**Request for Further Information - Engineering Response  
(South Dublin County Council Register Reference  
SDZ22A/0014)**

Phase 3 Proposed Development at Aderrig, Adamstown, Co.  
Dublin

March 2023

**Waterman Moylan Consulting Engineers Limited**

Figure 1: Proposed toucan crossing

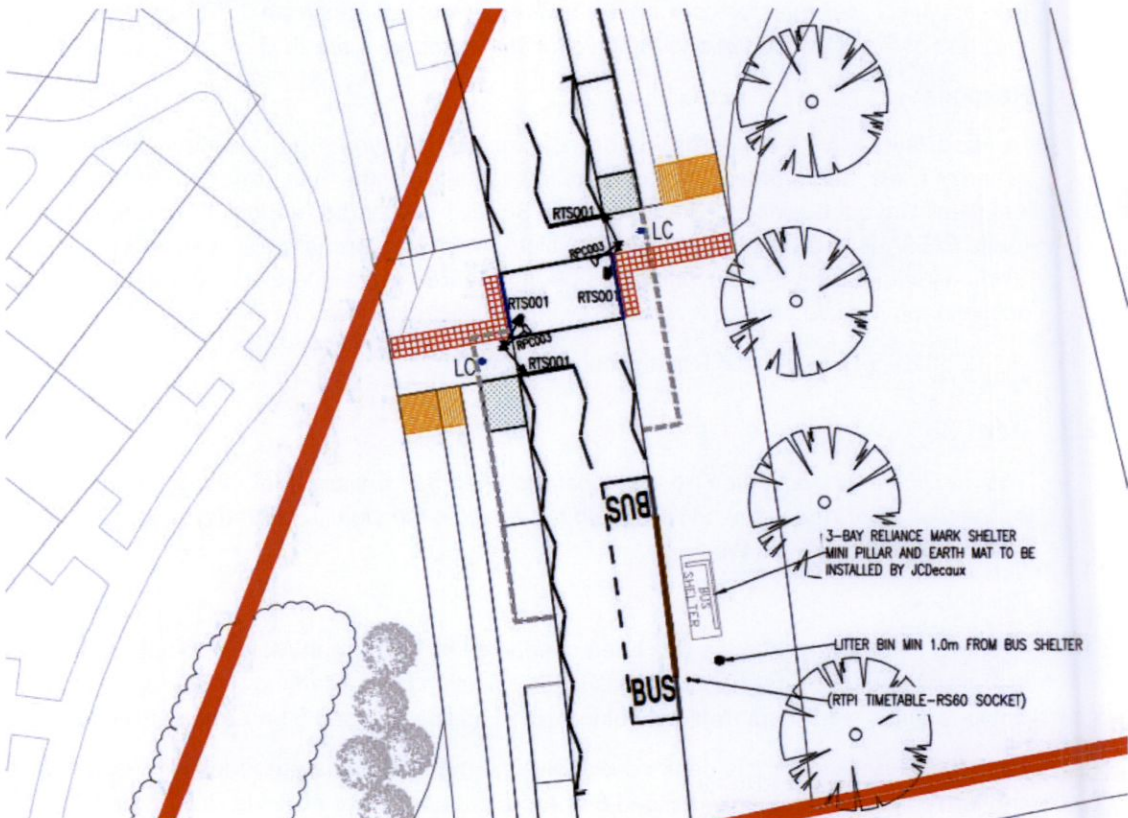
The applicant should provide clarification on how and where pedestrians and cyclists will cross the Celbridge Link Road.

It is proposed that, in addition to the signalized crossing at the junction of Adamstown Way and Celbridge Link Road, there will be a toucan crossing to the north of the Aderrig Phase 3 development, where pedestrians and cyclists will cross the Celbridge Link Road, refer to Figure 1.

The design of the toucan crossing has been discussed with the NTA and SDCC Roads Department and all comments implemented into the design. A road safety audit has been undertaken for the proposed bus stop and toucan crossing on Celbridge Link Road and the items raised have been satisfactorily addressed. A copy of this road safety audit is included as part of this further information response, refer to Appendix B.

Figure 2: Proposed northern toucan crossing and Celbridge Link Road Bus stop

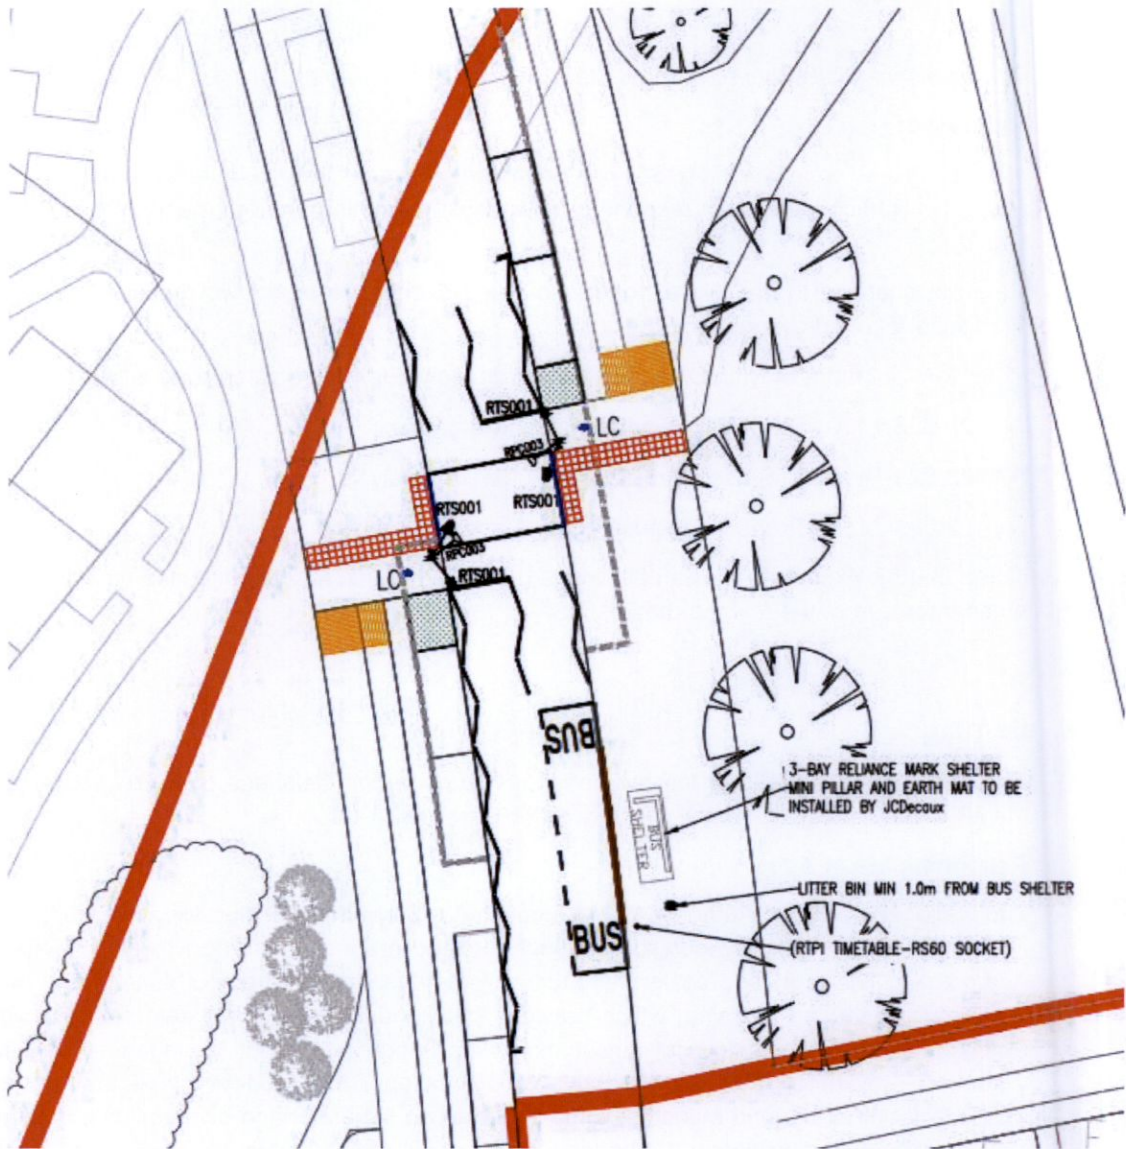
*The applicant should supply the additional bus stops on the Celbridge Link Road as requested by the NTA.*

The National Transport Authority (NTA) requested a preliminary design for an additional bus stop on the Celbridge Road C2 bus route adjacent to the proposed Aderrig Phase 3 development in Adamstown. The proposed design features a single bus stop on the southbound lane adjacent to the proposed toucan crossing, which provides pedestrians and cyclists safe passage across the Celbridge Link Road. Following consultation with Goodrock Project Management, the NTA and Waterman-Moylan on the proposed bus stop locations, it was determined that the preferred location of the northbound bus stop would straddle two separate land ownerships and therefore be excluded from this application. Celbridge Link Road will ultimately be taken in charge therefore the final design of the northbound bus stop can be undertaken by the relevant authority for statutory undertaking. The indicative location of which can be seen on Waterman-Moylan Drawing No. 22-023- SK099 – Masterplan.

The design criteria specified by the NTA has also been applied to the bus stops to the bus south of the Aderrig phase 3 site, which was previously proposed under the Adamstown Boulevard planning application (reference number SDZ22A/0007). The indicative southern bus stop locations are to be agreed upon with the SDCC and NTA via Condition No. 10 of the Boulevard Planning Application (Reg. Ref. SDZ22A/0007) (refer to Drawing number 22-023-T112 for indicative locations).

An RSA has been undertaken on the bus stop design on Celbridge Link Road and the items raised have been satisfactorily addressed.

Figure 2.1 – Junction Where a Tree Could Obscure Forward Visibility to a Stop Sign

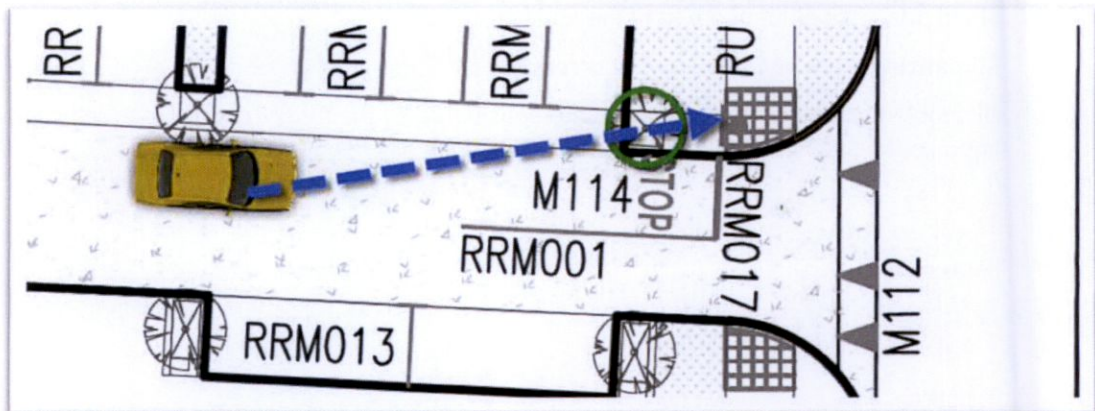
### 2.1 Problem: Trees Obscuring Road Signage

**Location:** Priority Control Junctions on Internal Streets

A tree obscuring a driver's forward visibility to the stop sign could increase the risk of late braking and conflicts with pedestrians attempting to cross the road.

Tree positions on all internal priority-controlled junctions should be checked to ensure that appropriate forward visibility is maintained to road signage (especially when the trees have reached maturity).

Problem Reference (Section 2)	Designer Response Section			Audit Team Response Section
	Problem Accepted ( yes / no )	Recommended Measure Accepted ( yes / no )	Alternative Measures or Comments	Alternative Measures Accepted ( yes / no )
2.1	YES	YES	Tree positions on all internal priority-controlled junctions have been checked to ensure that appropriate forward visibility is maintained to road signage. Tree pits which impede forward visibility have been removed from the design.	Noted with thanks.
2.2	YES	YES	We propose that the two trees in query are to be grassed landscape areas instead of trees. This will provide a clear line of sight throughout the length of bus stops and toucan crossing, ensuring that drivers are afforded with appropriate forward visibility to the traffic signal heads.	Noted with thanks.

Figure 2.2 – Trees Blocking Traffic Signal Heads

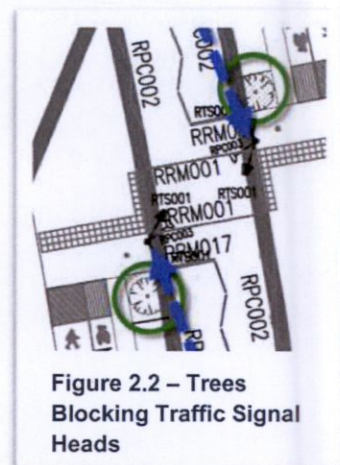
### 2.2 Problem: Trees Impacting on Traffic Signal Operation

**Location:** Signal Controlled Pedestrian Crossing

Drivers may not be able to see the traffic signal heads when the trees have reached full maturity. This could lead vehicles failing to stop at a red traffic signal resulting in conflict with pedestrians.

The location of the trees should be adjusted to ensure that drivers are afforded with appropriate forward visibility to the traffic signal heads.

**Figure 2.2 – Extension of Approach Zig Zag Markings**

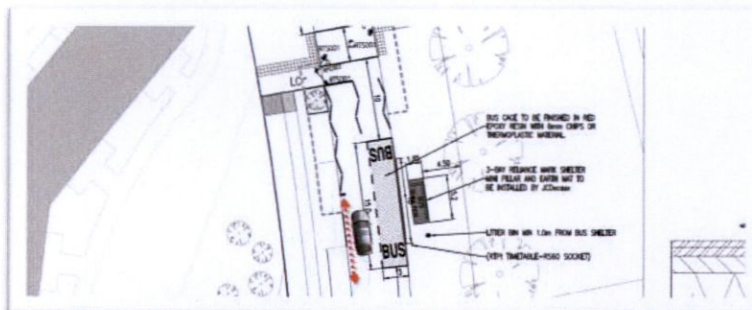
### 2.2 Problem: Extents of Crossing Controlled Area

**Location:** Approaches to Signalised Pedestrian Crossing

Terminating the approach zig-zag markings at the location proposed could indicate that it is safe for drivers to stop adjacent to the bus stop, within the crossing's controlled zone. This could increase the risk of pedestrian conflict and lead to delays and driver frustration.

The approach zig-zag road markings (and terminal lines) should be extended past the limits of the adjacent bus stop to indicate to drivers that it is not safe for them to stop within the crossing's controlled zone.

Problem Reference (Section 2)	Designer Response Section			Audit Team Response Section
	Problem Accepted ( yes / no )	Recommended Measure Accepted ( yes / no )	Alternative Measures or Comments	Alternative Measures Accepted ( yes / no )
2.1	YES	YES	We propose that the two trees in query are to be grassed landscape areas instead of trees. This will provide a clear line of sight throughout the length of bus stops and toucan crossing, ensuring that drivers are afforded with appropriate forward visibility to the traffic signal heads.	Noted with thanks.
2.2	YES	YES	The approach zig-zag road markings (and terminal lines) shall be extended past the limits of the adjacent bus stop to indicate to drivers that it is not safe for them to stop within the crossing's controlled zone.	Noted with thanks.
